Memorandum

Subject: Bassett Creek 2021 Flood Control Project Inspection

Date: October 14, 2021 **Project:** 23270051.52 2021 4065

Highway 55 Control Structure (Golden Valley/Minneapolis)

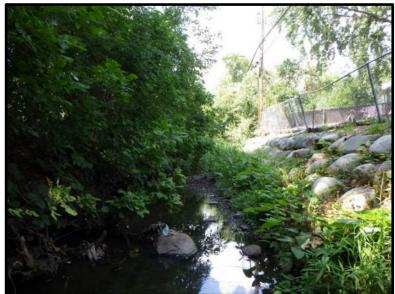
- a. The concrete control structure appeared to be in satisfactory condition.
- b. A hairline crack was observed in the east (left) wall of the inlet structure, although it appears that the crack may have been previously sealed with caulk. The crack is positioned in the middle of the wall extending full height. This is consistent with previous inspections and has been noted since 2002.

- c. Erosion was observed around the east (left) side of the structure, likely from road runoff. In the summer of 2021, Minnesota Department of Transportation (MnDOT) crews placed class 5 aggregate on the east (left) side of the structure to access the upstream end of the structure to preform repairs of the double box culvert below Highway 55. The new class 5 aggregate is actively eroding.

- d. MnDOT crews also drilled holes into the structure to install brackets and a temporary plate to block flows through the structure so they could perform repairs. MnDOT removed the plate, brackets, and bolts, but did not fill or repair the bolt holes.

- e. A piece of rebar and relatively small mass of concrete extended into the lower west (right) side of the opening of the low flow weir. A steel threaded rod extended approximately 2 inches from the south face of concrete on the east (left) side of low flow weir. These observations have not been noted in previous years' inspections, but water levels were lower in 2021 than previous years, exposing this part of the structure for the first time or since 2015.

- Protect the sides of the structure with armoring (rock or riprap) or reinforced vegetation to limit additional erosion. Alternatively, divert road runoff away from the structure.
- Request that MnDOT repair bolt holes with concrete gout.
- Sawcut and remove rebar and concrete chunk on east (left) side of low flow weir.
- Sawcut steel rod to be flush to concrete along south face of concrete on the east (left) side of the low flow weir.
- Monitor hairline crack in the control structure.

Highway 100 Double Box Culverts (Crystal/Golden Valley)

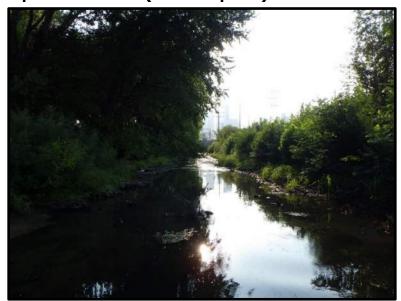
- a. The concrete box culverts and concrete inlet structure appeared to be in satisfactory condition.
- b. Circumferential cracks and areas of spalled concrete were observed in the north (left) box culvert.
- c. Longitudinal cracks, circumferential cracks, and areas of spalled concrete were observed along the top of the south (right) box culvert. MnDOT performed repairs to the culverts in 2007, but cracks have been noted since 2008 and areas of concrete spalling have been noted since 2014.
- d. Deposited sediment was observed in the north (left) box culvert, generally ranging from 6-24 inches deep. This is consistent with previous inspections and 6-24 inches of deposited sediment has been observed in the north (left) box culvert since 2002.
- e. The outlet portion of the structure appeared to be in satisfactory condition.

- Monitor accumulated sediment in north (left) box culvert and consider future removal.
- Monitor cracking and spalling concrete in both box culverts.

Open Channel (Minneapolis), continued

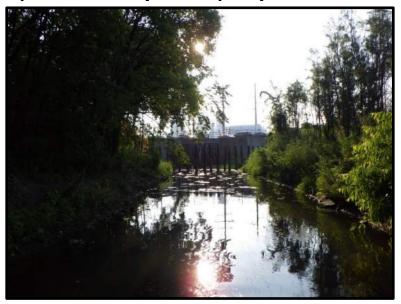
- a. The open channel, from Van White Memorial Boulevard to the inlet structure, appeared to be in satisfactory condition.
- b. The banks were generally vegetated. Some areas had exposed soil and steep slopes but seemed stable and no obvious signs of bank erosion were noted.
- c. Sediment has deposited and formed a delta on the south (right) side of the channel between the debris barrier and inlet structure. Vegetation was growing on the delta and approximately one-quarter of the channel was blocked by the sediment, debris, and vegetation. This is consistent with last year's observation.
- d. A new outfall with riprap armoring was installed from the Minneapolis impound lot.

- Remove accumulated sediment and debris on the south (right) side of the channel between the inlet structure and debris barrier.
- Monitor downed tree(s) and debris and remove as needed.
